LIGO HANFORD OBSERVATORY

MEMORANDUM

TO: ISC team
FROM: Daniel Sigg
SUBJECT: Modifications to the slow generic filter stage
Refer to: LIGO-E1700187-v1

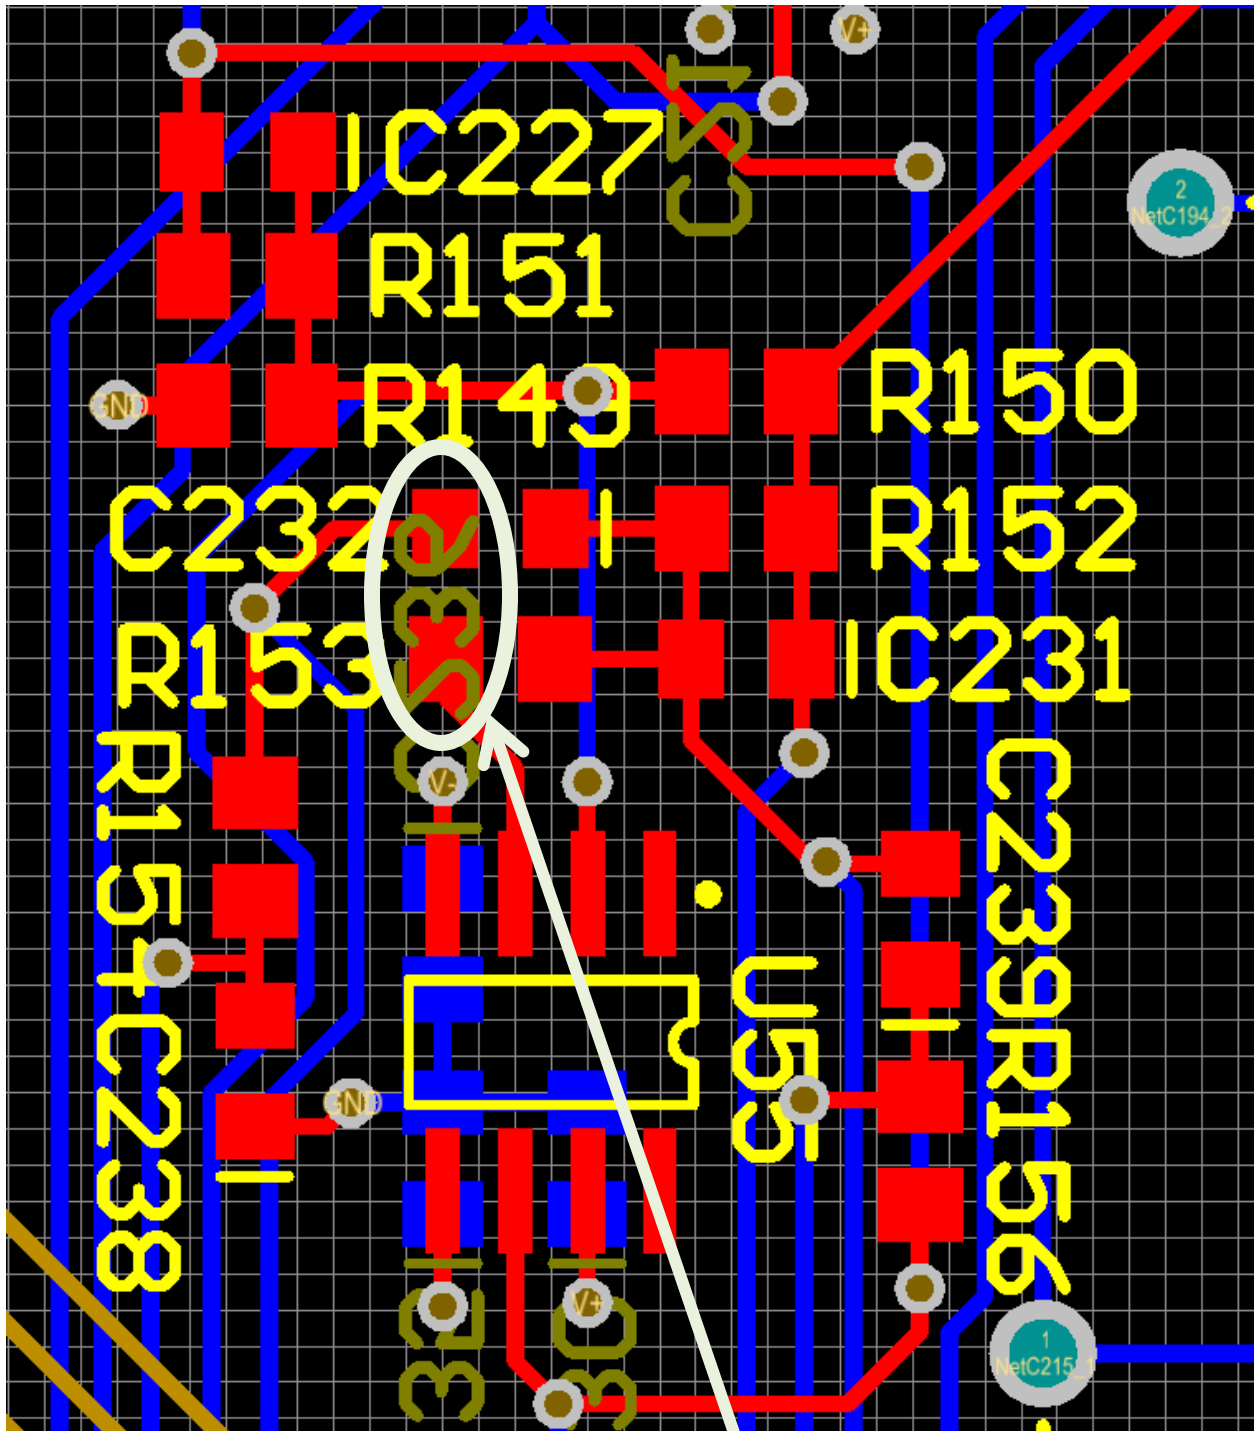
The slow generic filter stage of the revision E of the common mode board (D040180) contains a layout error with a missing junction/connection. This problem only manifests itself, if the generic stage uses either the Z2 or Z3 impedance circuit blocks.

To modify the PCB orient the board with the component side up and with the TNC/BNC connectors located at the top.

Solution A: Install a jumper or short between the left pads of C232 and R153. This will implement the missing junction/connection.

Solution B: Install a jumper or short between the left pad of C232 and the right pad of R149. This will connect Z3 to the negative input of the operational amplifier. The servo boards for the squeezer are using this solution to implement a lead filter.
